CITY OF ALBUQUERQUE

**Re: Heritage Market Place
1820 Unser Blvd., NW
Request for Temporary Certificate of Occupancy- Transportation Development**
Engineer's/Architect's Stamp dated 4-9-15 (H09-D024)
Certification dated 1-04-16

**RE: SITE PLAN FOR BUILDING PERMIT CERTIFICATION
CERTIFICATION FOR TEMPORARY CERTIFICATE OF OCCUPANCY
HERITAGE MARKET WALMART, 1820 UNSER BLVD NW**

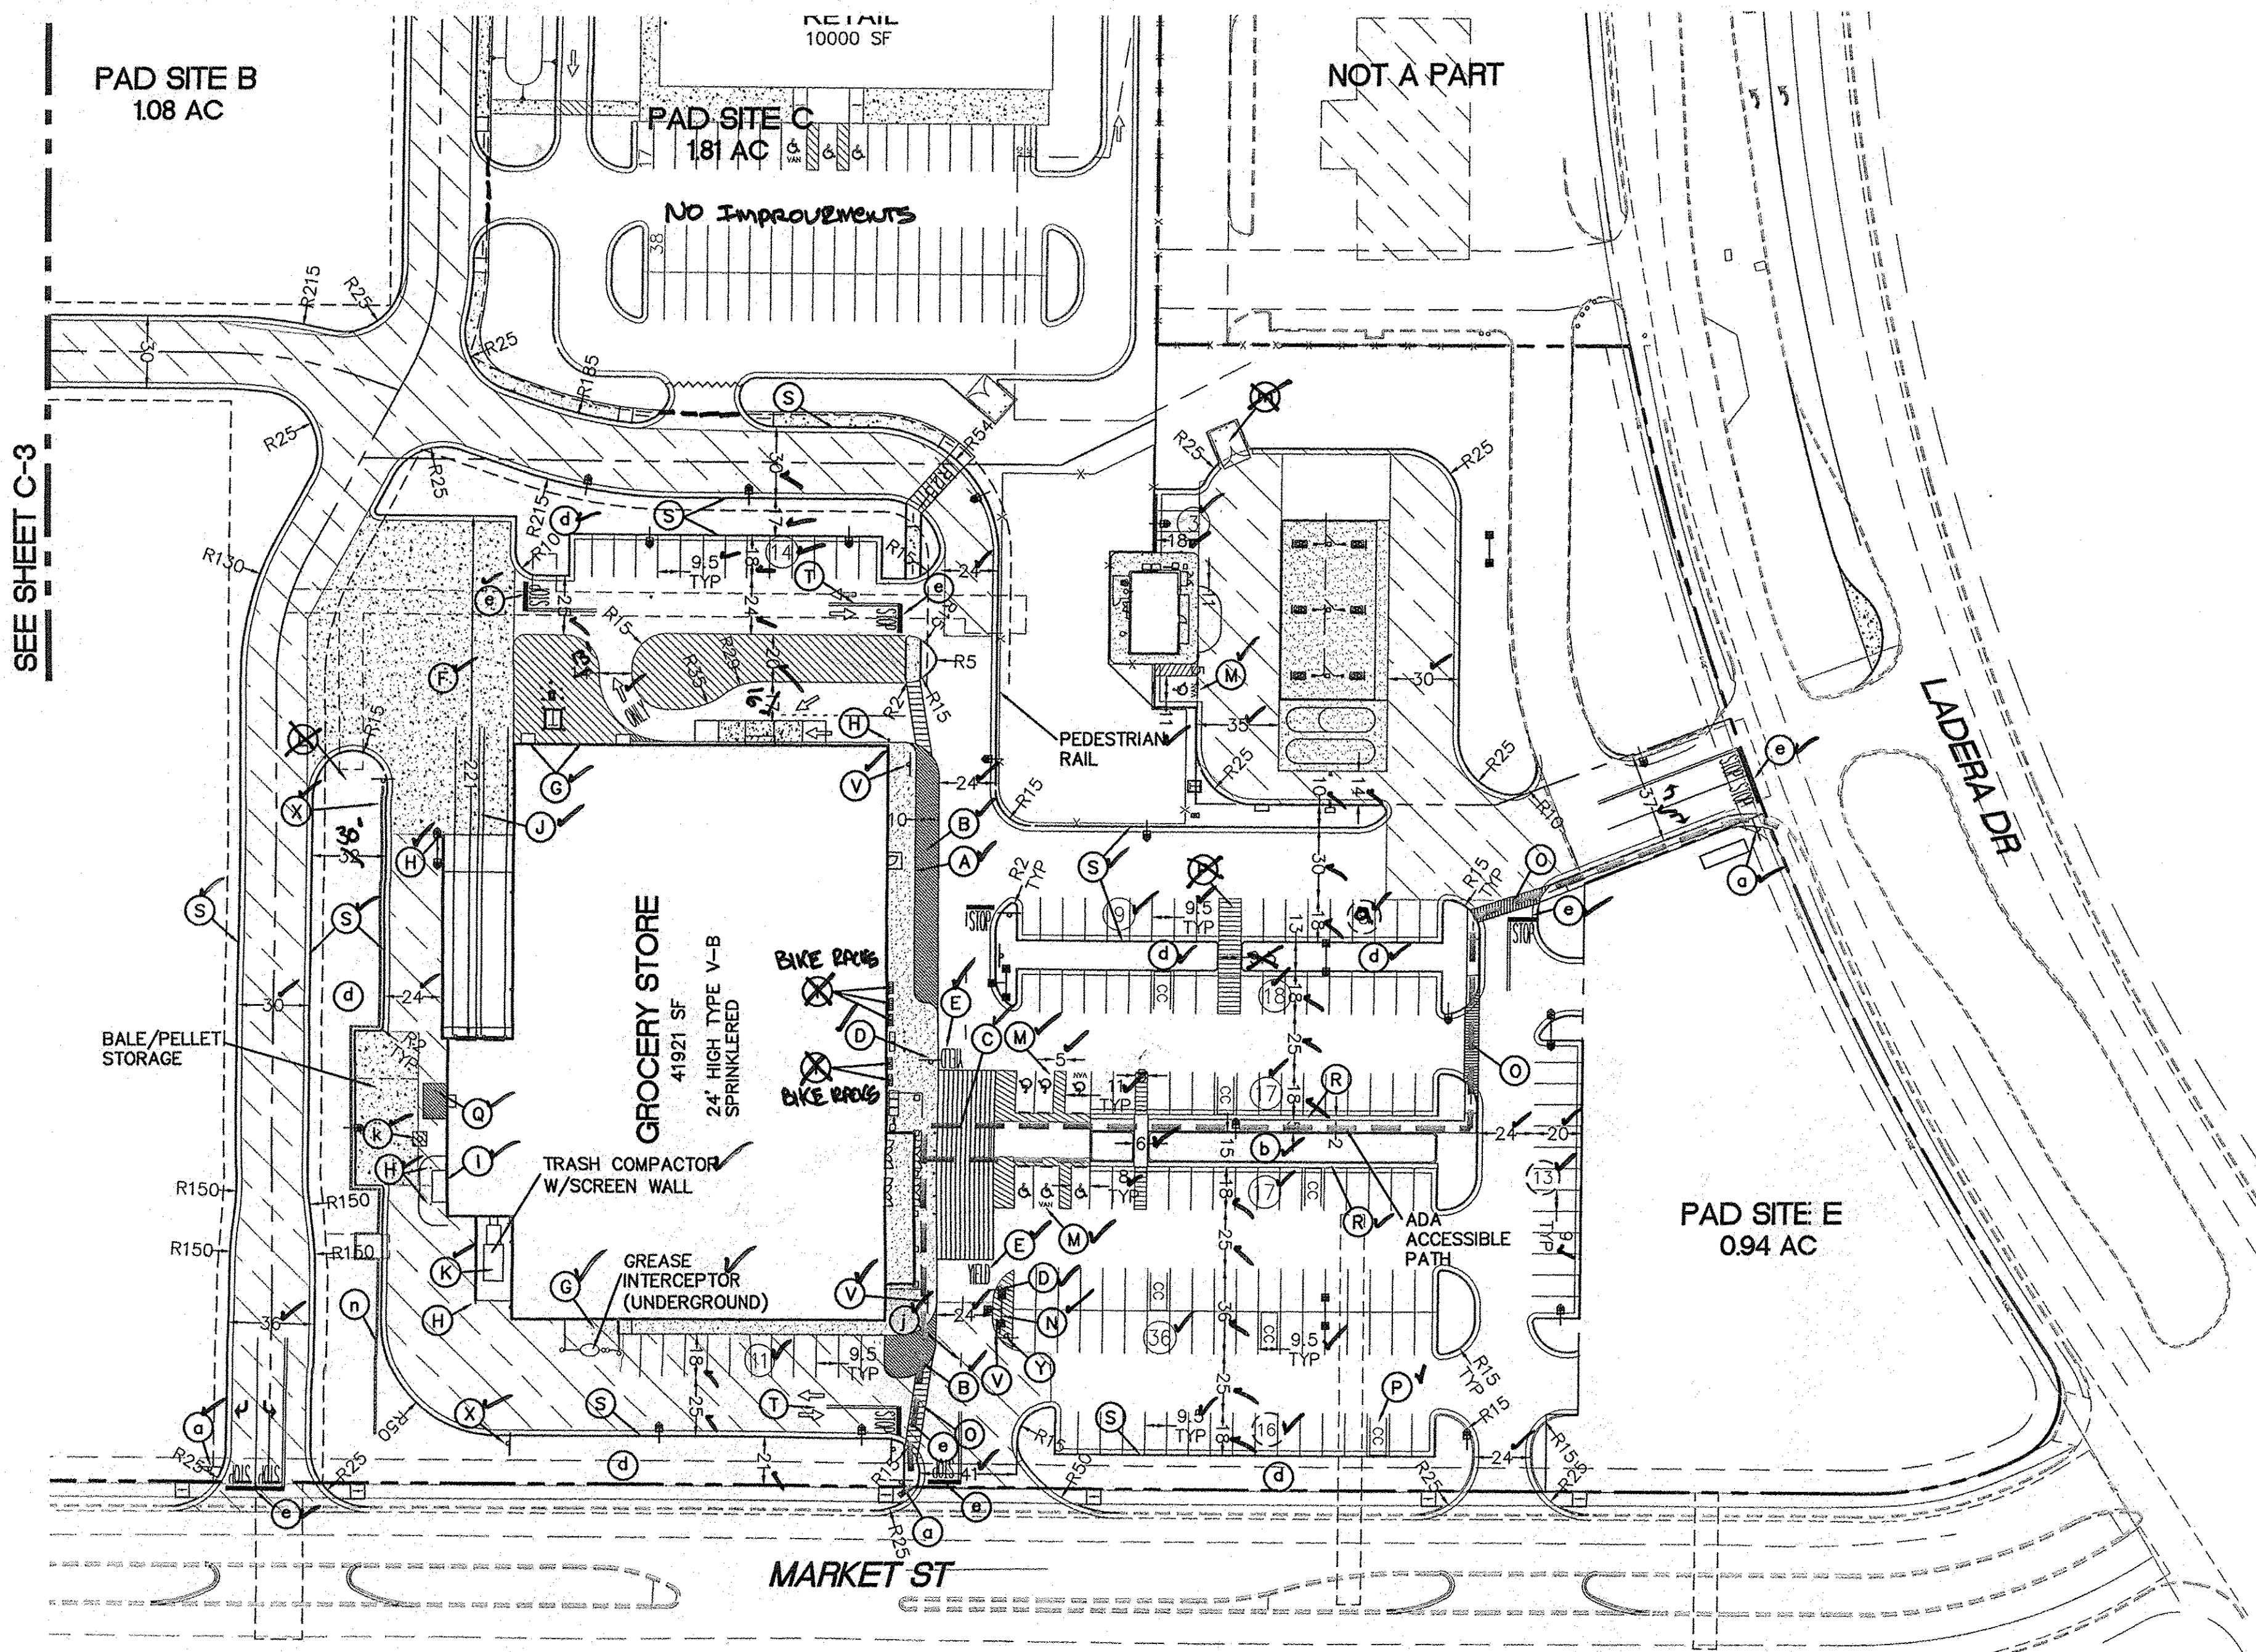
1. Truncated domes along all public Right of Ways need to be installed.
2. ADA parking spaces do not meet number of required spaces. ADA pavement between ADA parking spaces needs to be marked with cross hatching.
3. Motorcycle parking is missing and required.
4. "No Trucks" sign Key Note "K" needs to be installed at the eastern entrance.
5. Painted "Yield" on pavement on the north side of store needs to be repainted, due to discoloration.
6. Work Order must be complete and accepted prior to final C.O.

PARKING REQUIRED	210 SPACES (1 SPACE PER 200 SF) GROCERY
PARKING REQUIRED	4 SPACES (1 SPACE PER 200 SF) GAS LOT
TOTAL PARKING REQUIRED	214 SPACES
PARKING PROVIDED	160 SPACES (GROCERY) + 4 (GAS LOT)
HC PARKING REQUIRED	8 SPACES
HC PARKING PROVIDED	7 SPACES (GROCERY) + 1 (GAS LOT) (ADD ADD SPACE)
TOTAL PARKING PROVIDED	164 SPACES
MC PARKING REQUIRED	5 SPACES
MC PARKING PROVIDED	5 SPACES (ADD MC PARKING)
BICYCLE PARKING PROVIDED	25 SPACES (5 RACKS)

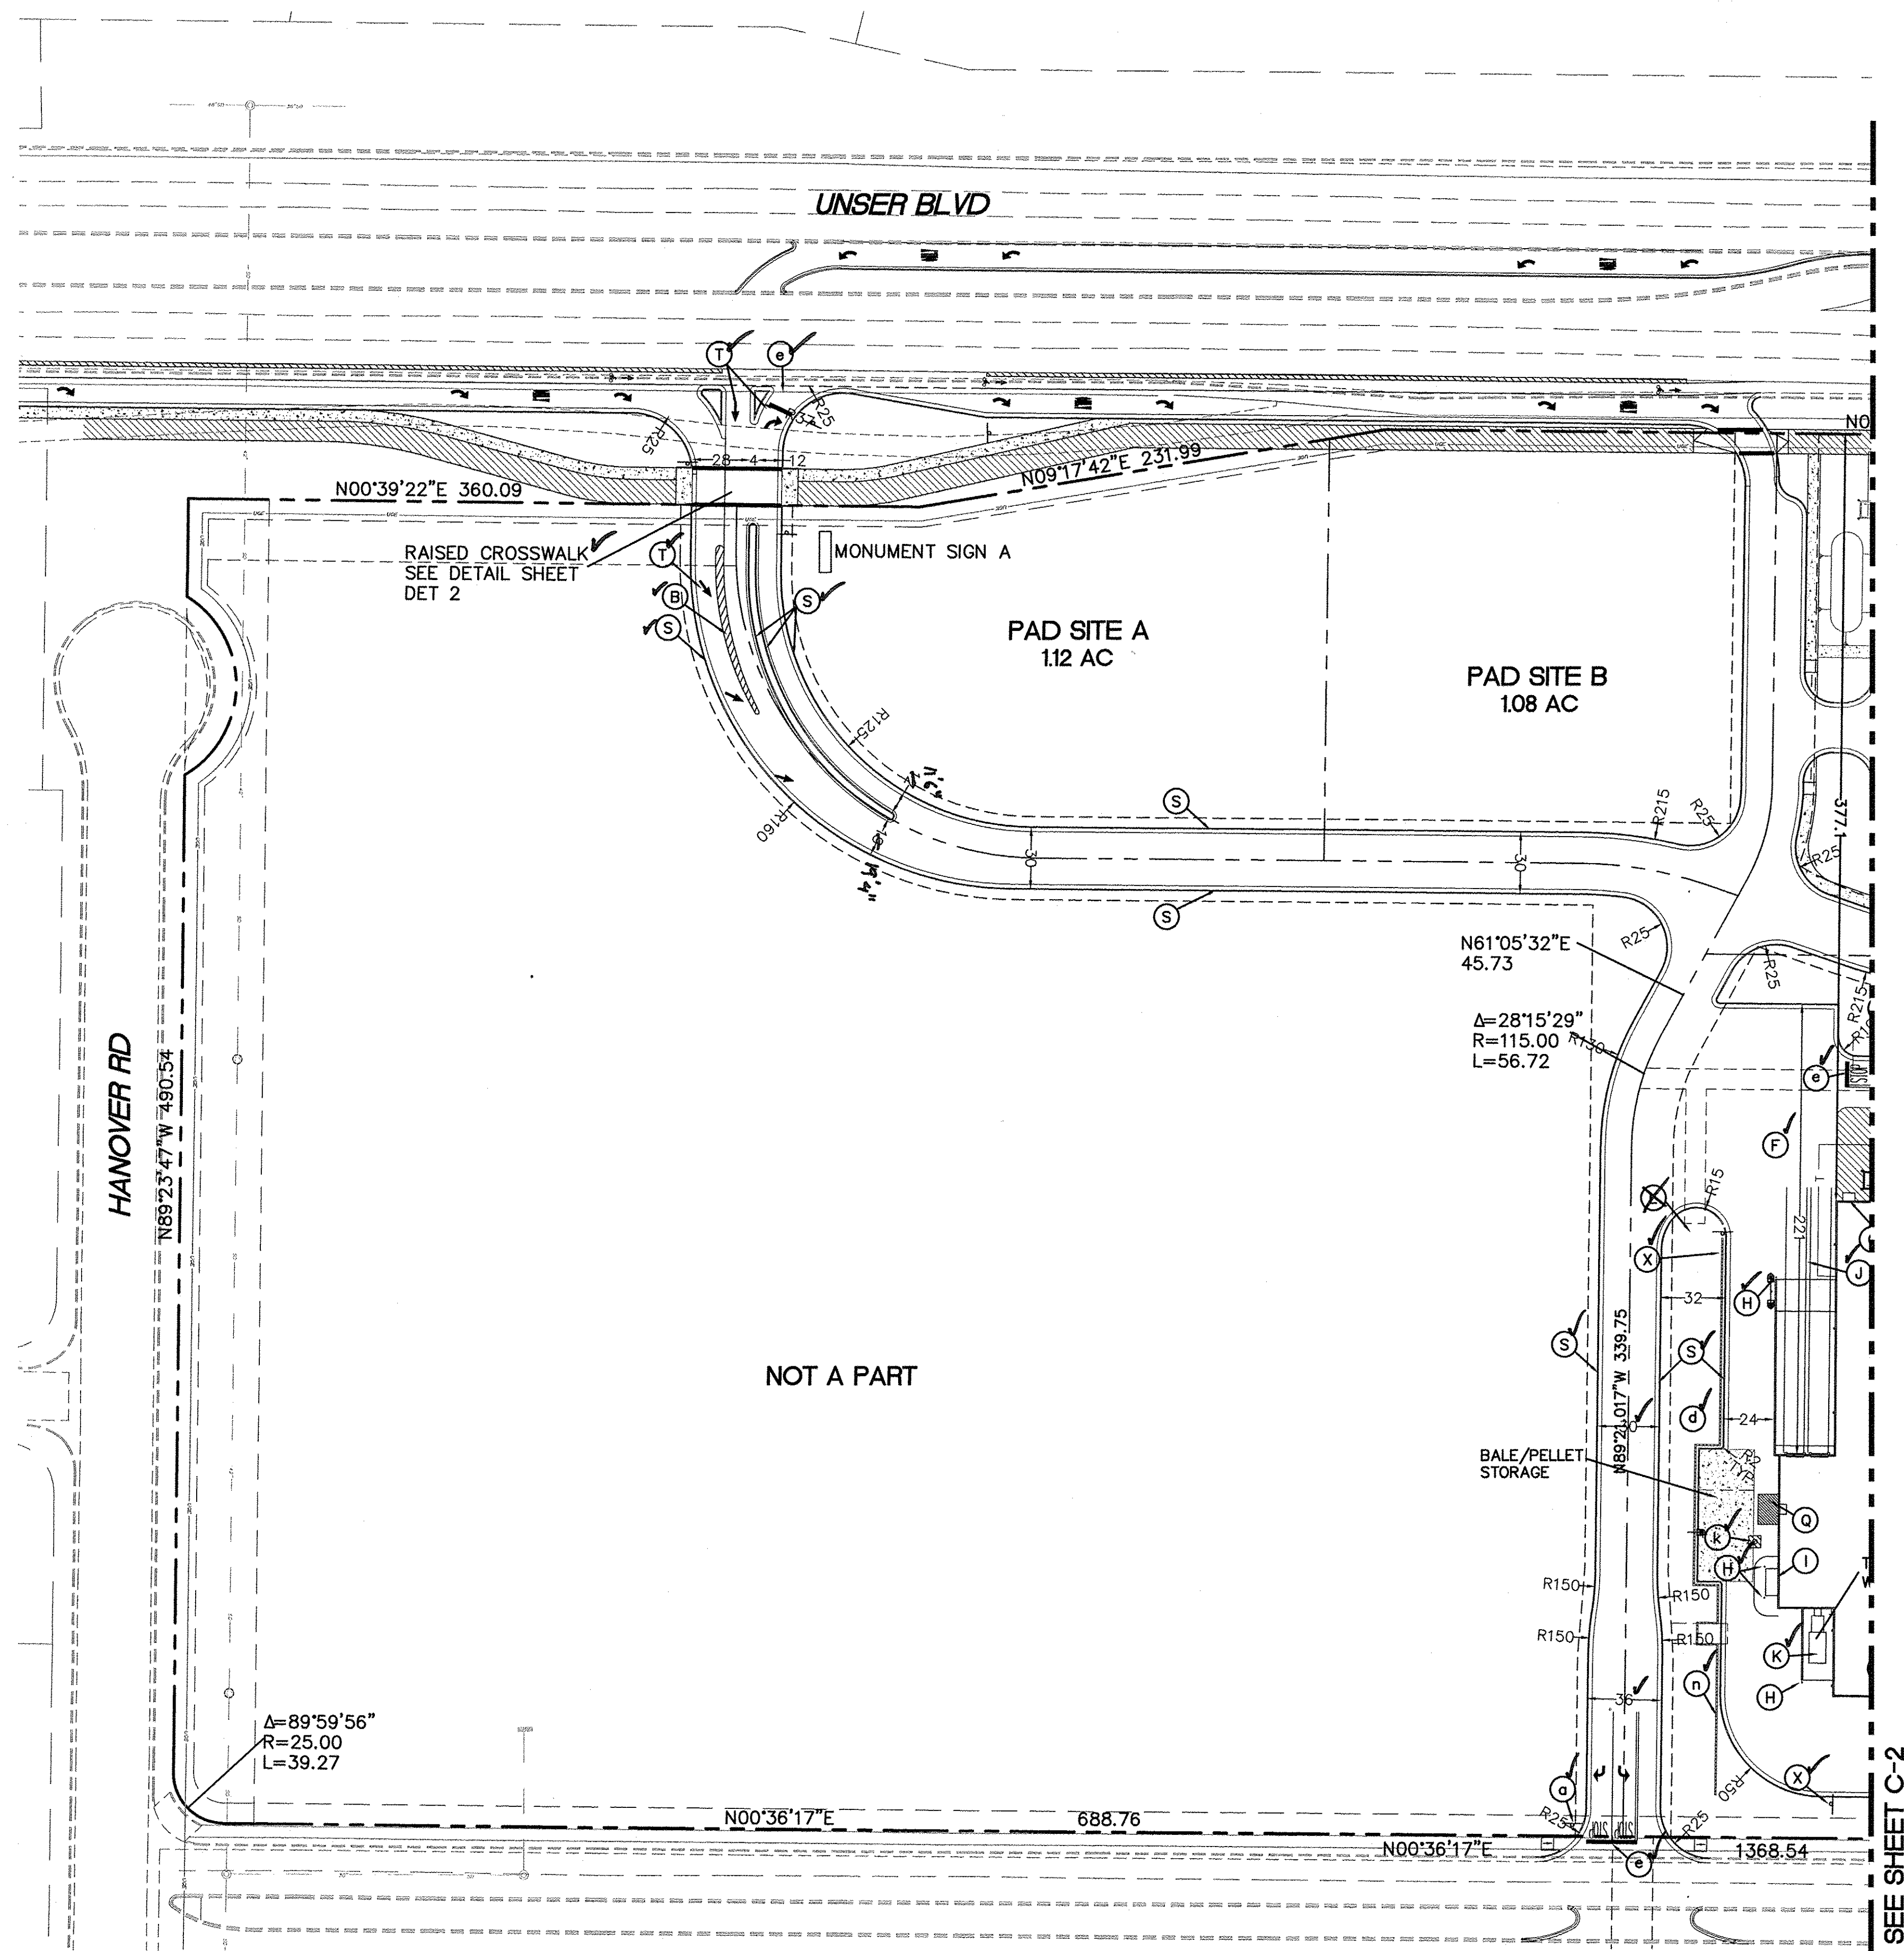
- ✓(H) 6" DIA PIPE BOLLARD TYPICAL UNLESS NOTED OTHERWISE. SEE DETAIL SHEET C-8 *MISSING AT COMPACTOR R, NW BUILDING CORNER*
- ✓(I) AT GRADE OVERHEAD DOOR LOCATION. SEE ARCHITECTURAL PLANS FOR EXACT SIZE AND LOCATION FOR COORDINATION WITH CIVIL PLANS.

- ✗ CONCRETE TRANSFORMER PAD. CONTRACTOR TO COORDINATE WITH LOCAL POWER COMPANY FOR DETAILS. *MOVED TO SW CORNER OF BUILDING*
- ✓(M) ACCESSIBLE PARKING SPACE TYPICAL. SEE DETAIL SHEET FOR ACCESSIBLE PARKING SPACE SIZE, SIGN AND SYMBOL ("VAN"-INDICATES VAN ACCESSIBLE SPACE). *LACKING ONE SPACE TO BE ADDED*

- ✓(O) 8'-0" WIDE PEDESTRIAN CROSSWALK. SEE DETAIL SHEET C-8
- ✓(P) CART CORRAL TYPICAL. SEE DETAIL SHEET C-9 - *Temp locations*
- ✓(Q) 10' X 15' STRIPED AREA PAINTED SYSL/4" AT 45' @ 2'-0" O.C. AT JIB CRANE LOCATION. SEE ARCH. PLANS.

- ✓(T) ARROW PAVEMENT MARKINGS TYPICAL. SEE DETAIL SHEET C-8
- ✓(U) BUILDING SETBACK LINE PER ZONING ORDINANCE.
- ✓(V) "NO PARKING FIRE LANE" SIGN. SEE PLAN FOR LOCATION. *MISSING SIGN AT ENTRANCE AT MARKET ST.*

- ✗ 3' HD CONCRETE BUFFER FOR LANDSCAPE PROTECTION. SEE DETAIL SHEET C-8 *NOT USED*
- ✗ "DELIVERY TRAFFIC ONLY" SIGN. SEE DETAIL SHEET C-10 *NOT USED*
- ✓(Y) "NO TRUCKS" SIGN. SEE DETAIL SHEET C-10 *MISSING SIGN AT ENTRANCE AT MARKET ST.*

- ✗ ADVANCED INTERSECTION LANE CONTROL SIGN. SEE DIRECTION INDICATED AT SYMBOL. SEE DETAIL SHEET.
- ✓(i) ACCESSIBLE "SITE ARRIVAL POINT". SEE PLAN FOR LOCATION AND LIMITS. *- ROUTE TO BE CERTIFIED*

- ✓(n) *SCREEN WALL (CMU)*
